American Telecommunications Certification Body Inc.
6731 Whittier Ave, McLean, VA 22101

RE: Wistron Corporation

FCC ID: H9PMC3574

After a review of the submitted information, I have a few comments on the above referenced Application. Depending on your responses, kindly understand there may be additional comments.

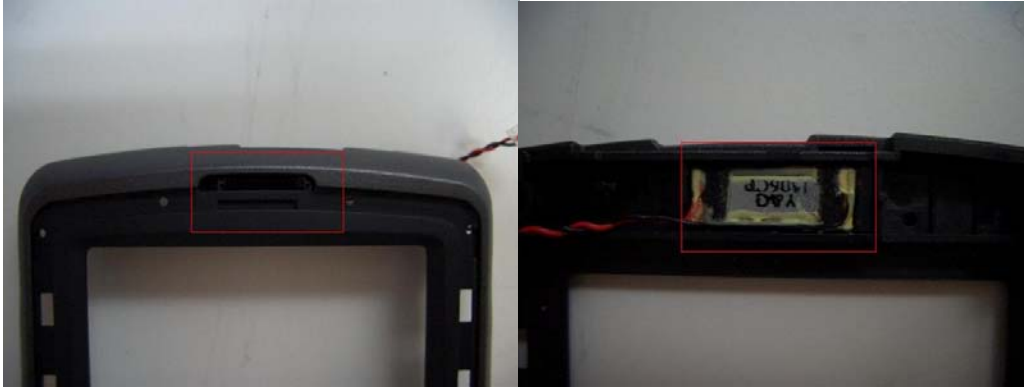
- 8) It is uncertain if the T-coil location is also the center of the acoustic location. If the T-Coil location is in a different location from the acoustic output, then two different 5 cm by 5 cm areas are to be scanned for Acoustic Mode Testing. The first for the microphone mode assessment and the second for the T-Coil assessment. The location of the microphone mode 5 cm by 5 cm area is centered on the acoustic output of the WD and is defined in Clause A.2 and depicted in Figure A.2. The location of the grid for the T-Coil assessment is identical in shape but is centered on the T-Coil axial measurement location, as defined in Clause A.3 and depicted in Figure A.3.

Please check these pictures which shows the location of HAC position is same as Acoustic position. Please let us know it is not a problem now.
